Schramm Property: Preliminary Plan No. 120150140

Staff Report Date: 8/26/16

Schramm Property: Preliminary Plan No. 120150140
Request to create a 2.63 acre lot from Parcel 554
(8365 Warfield Road); Located on the north side of
Warfield Road, approximately 700 feet east of
Doubleland Road; 2.72 acres; RE-2 Zone; Agricultural
and Rural Open Space Master Plan.

Figure E - Tree Variance

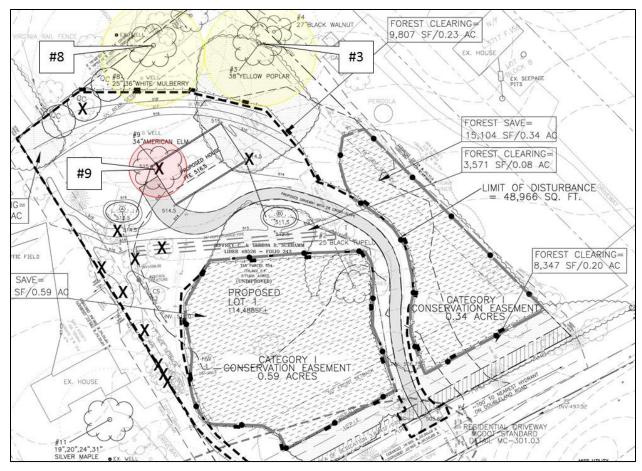
<u>Variance Request</u> - The Applicant submitted a variance request in a letter dated April 18, 2016 (Attachment F). The Applicant proposes to remove one and impact two specimen trees that are 30 inches or greater DBH, that are considered high priority for retention under Section 22A-12(b)(3) of the County Forest Conservation Law.

<u>Mitigation for Trees Subject to the Variance Provision</u> - There is one tree proposed for removal in this variance request which results in 34 inches of DBH being removed. For removal of specimen trees associated with a variance request, Staff recommends mitigation for the tree loss by replacing the total number of DBH removed with one quarter of the amount of inches replanted. This results in a total mitigation of 8.5 inches of replanted trees (34/4= 8.5). In this case, the Applicant proposes to plant three 3" caliper overstory trees native to the Piedmont Region of Maryland on the Property.

<u>Variance Recommendation</u> - Staff recommends approval of the variance request.

Figure C - Preliminary Plan

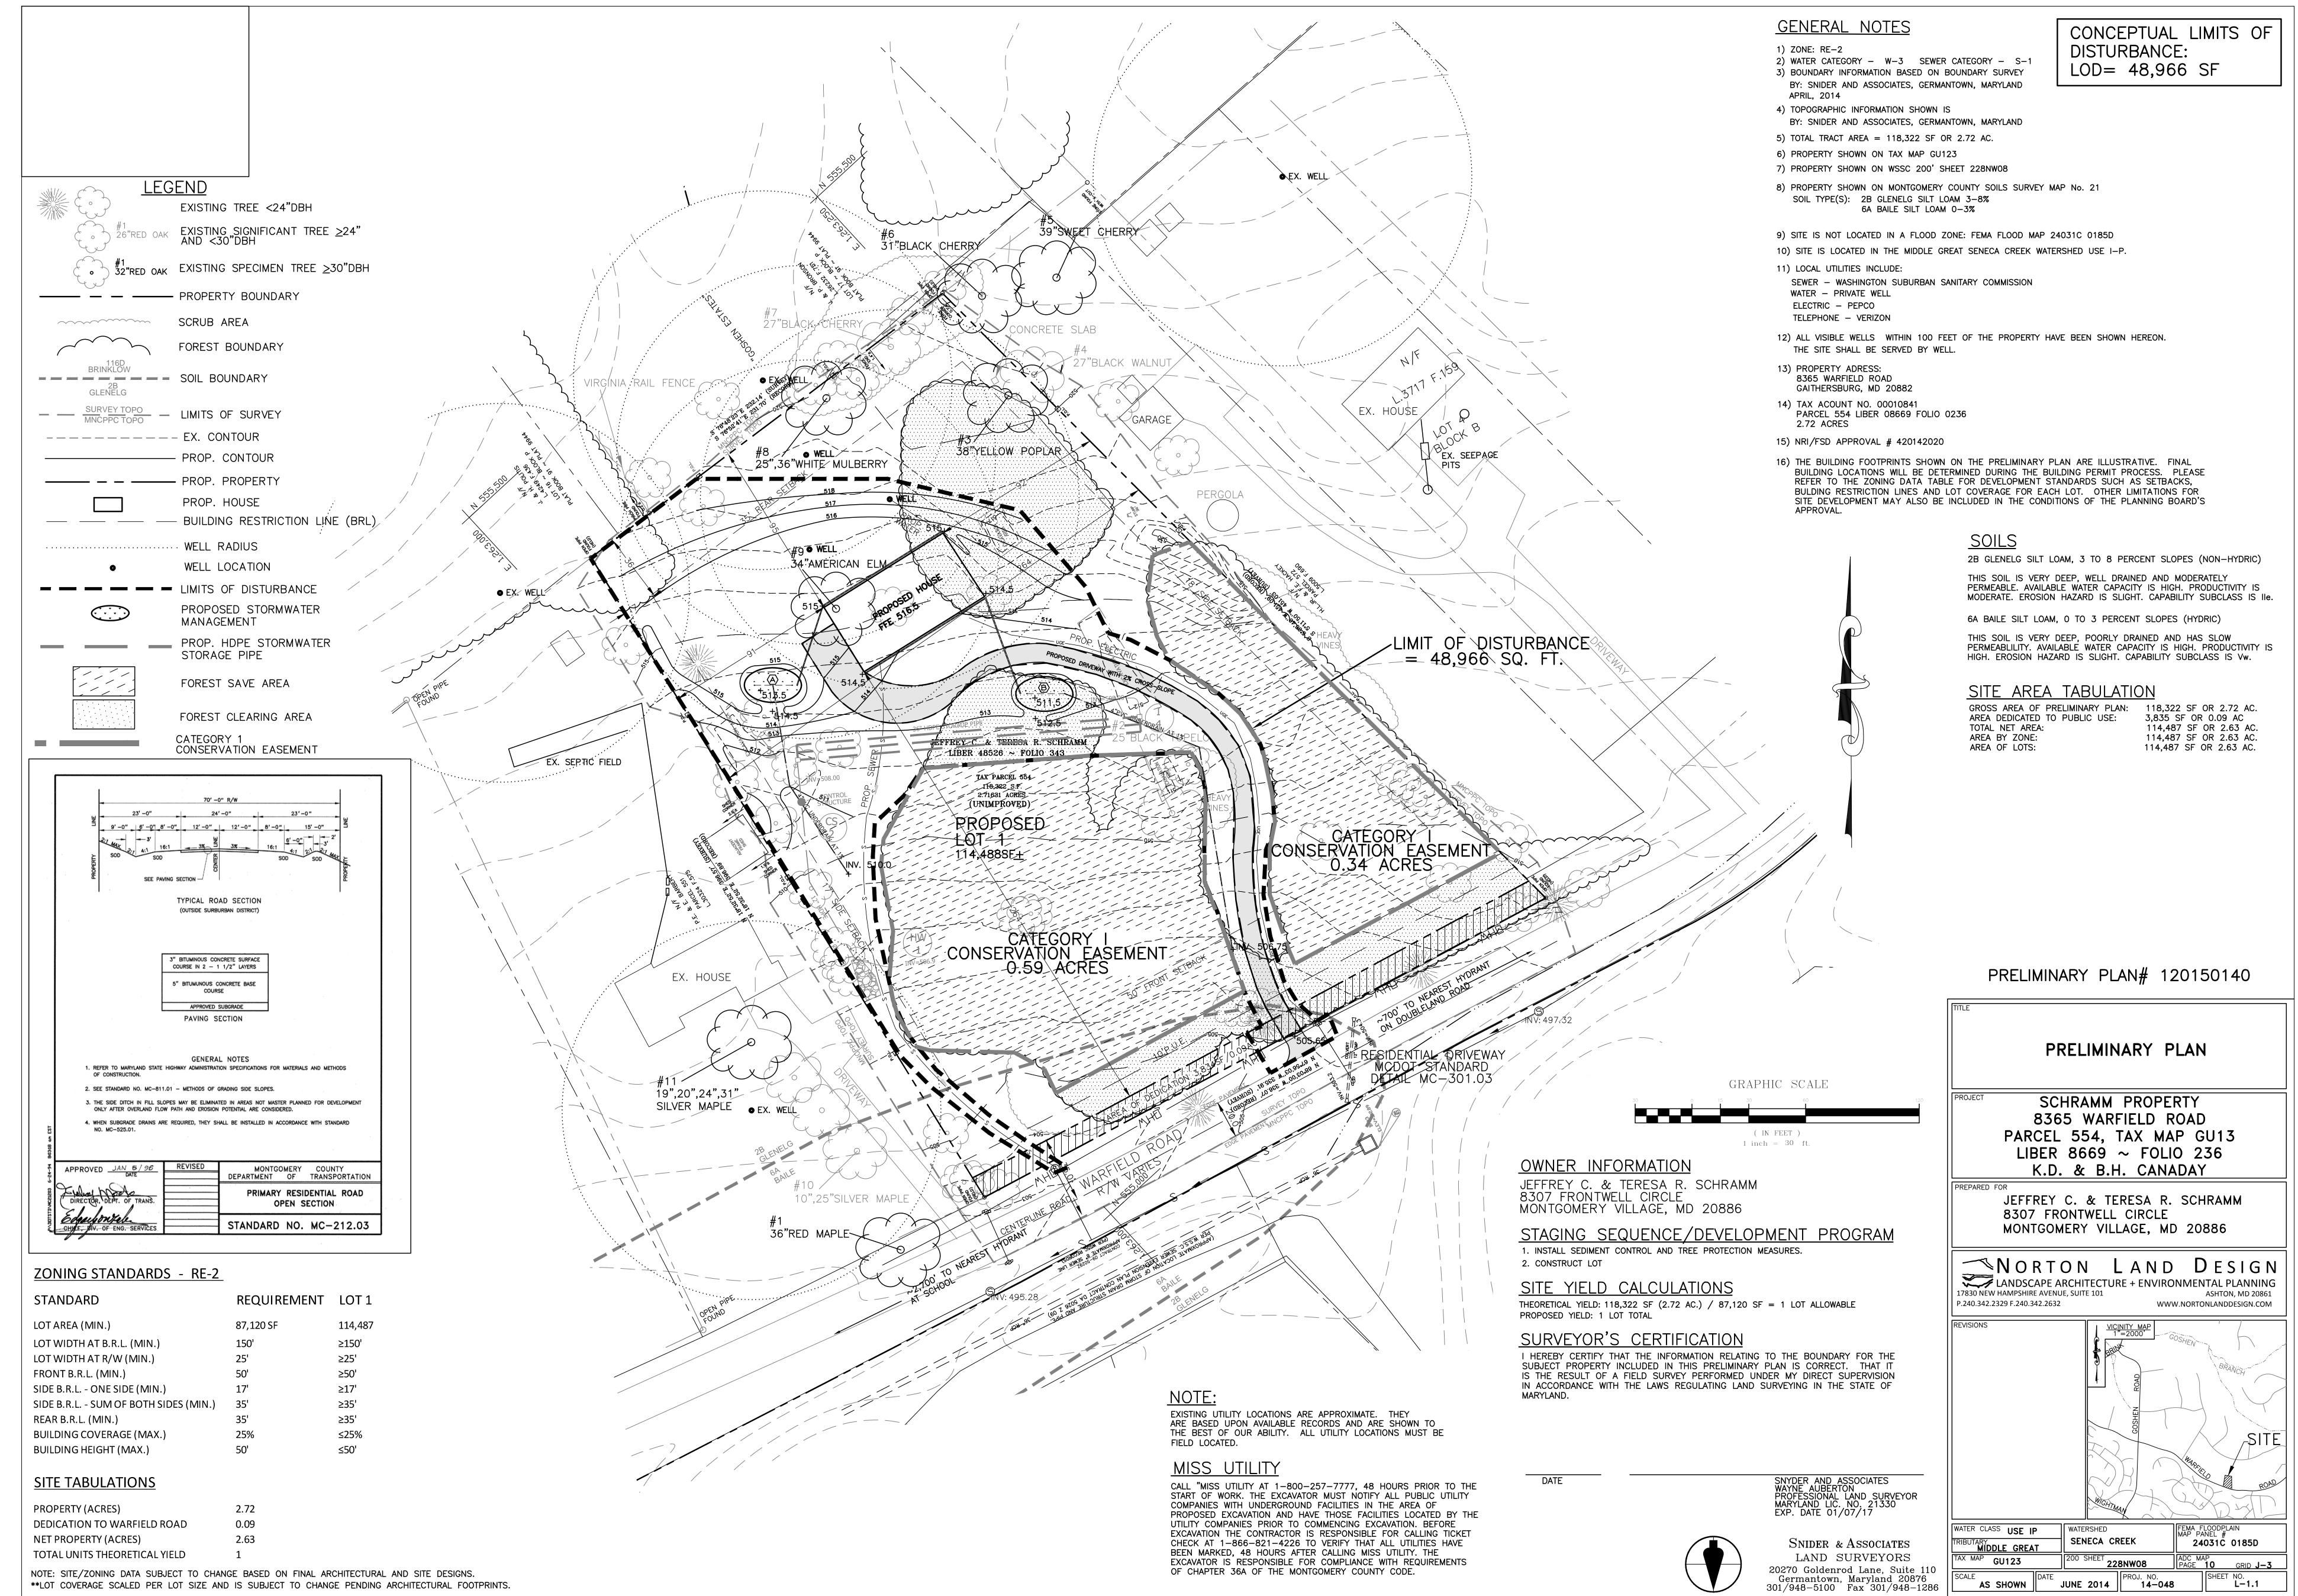
Preliminary plan application No. 120150140, Schramm Property ("Application" or "Preliminary Plan") proposes to convert an existing parcel into a single lot for the construction of a one-family detached residential dwelling unit (Figure C). The Property has frontage on Warfield Road, a public road, which will serve as the access to the lot via a new driveway. Applicant is dedicating 3,835 square feet (0.09 acres) along the Property's frontage to achieve the full master planned right-of-way width required for on the Warfield Road.

The Applicant will install a private well and connect to existing community (public) sewer, as shown on the Preliminary Plan. The use of a private well and public sewer is consistent with the Property's current W-3 and S-1 category. Stormwater quantity and quality will be managed onsite via the use of micro biofiltration. The Application also includes a tree variance for impact to two specimen trees, and removal of one specimen, as discussed further in the required tree variance request in the Forest Conservation Tree Variance section on page 9.
